Staff Report: Z-2-19-4 May 24, 2019

Request To: C-2 HGT/WVR DNS/WVR (1.73 acres)

Location Northeast corner of 12th Street and

The Clayton 1200 E Highland Ave Phoenix, AZ

Source: K & I Homes, LLC

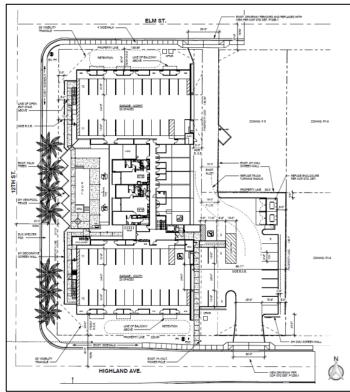
The conceptual site plan proposes a 34-unit multi-family project encompassed within a singular building. The ingress and egress is off Elm Street and Highland Avenue and parking is provided in the form of surface parking within the southeast portion of the site and structured garage parking below the second story units along the north and south portion of the property. The building and the open space amenity area is oriented along the west side facing 12th Street to promote an engaging pedestrian environment. To further the pedestrian experience, staff has requested that the western facing elevations include decorative view fencing into the

open space, breeze blocks, balconies and surface parking to be provided behind buildings to help provide an active and pedestrian friendly frontage along 12th Street. These are addressed in Stipulation Nos. 6 and 9.

- 1. The development shall utilize the R-4 development standards.
- 2. The maximum building height shall be limited to 36 feet.
- 3. A minimum 80-foot building setback shall be provided along the eastern property line adjacent to the single-family zoning district.

- 9. Any off street surface parking adjacent to 12th Street must be located behind a building, as approved by Planning and Development.
- 10. A minimum of 10% of the interior surface parking lot area shall be shaded with landscaping, as measured on the summer solstice at noon, and as approved by the Planning and Development Department.

Sketch Map
Aerial
Site Plan date stamped May 1, 2019
Elevations and Renderings date stamped May 1, 2019 and May 22, 2019 (3 pages)

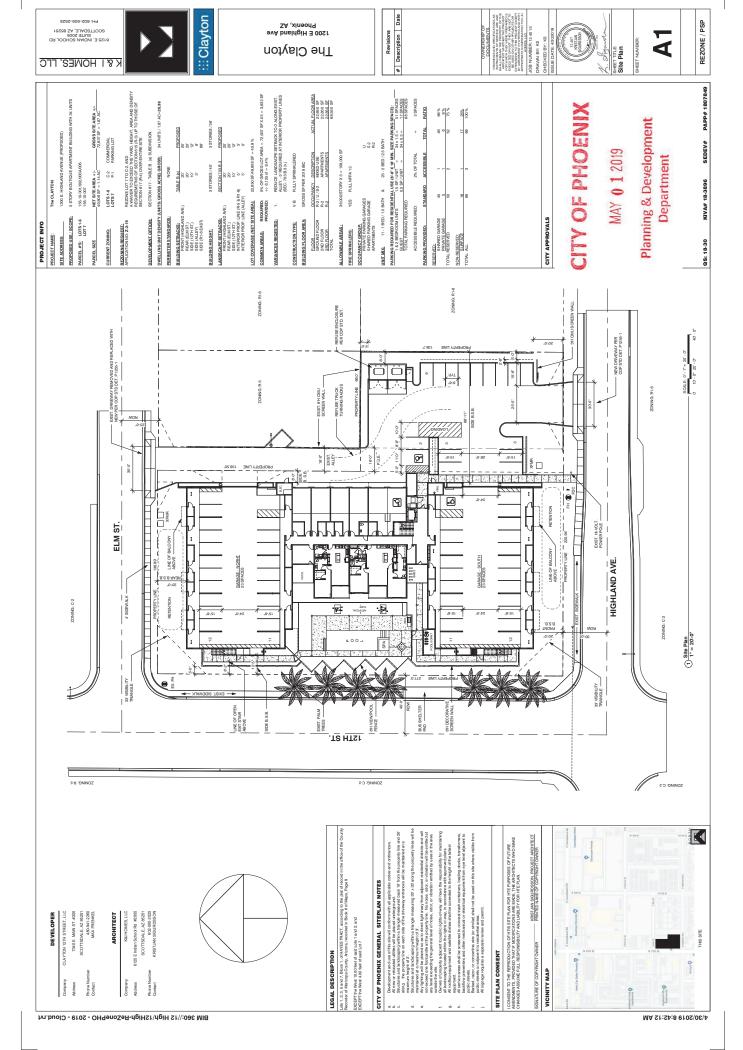
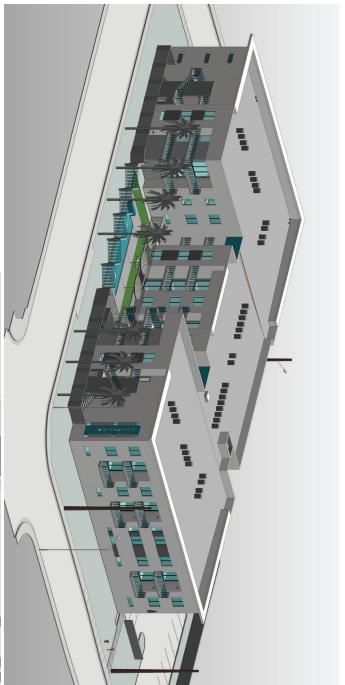
The conceptual elevations include a variety of exterior colors and materials which include stucco, metal, glass and masonry with balconies along each side of the building. Staff had requested that all balconies facing 12th Street be a minimum of 8 feet in depth and 12 feet in width and that the final elevations contain architectural embellishments, offsets, recesses and textural changes. These are addressed in Stipulation Nos. 5 and 6.c.

- 5. The building shall contain architectural embellishments and detailing such as textural changes, pilasters, offsets, recesses, variation in window size and location, and/or overhang canopies, as approved by the Planning and Development Department.

- a. There shall be decorative view fencing along the open space area that is consistent with the balcony railings as depicted on the elevations and renderings date stamped May 1, 2019 and May 22, 2019.

- b. A minimum of 40% of the perimeter wall shall be decorative breeze block.
- c. All individual units shall contain balconies that are a minimum of 8 feet in depth and a minimum of 12 feet in width.
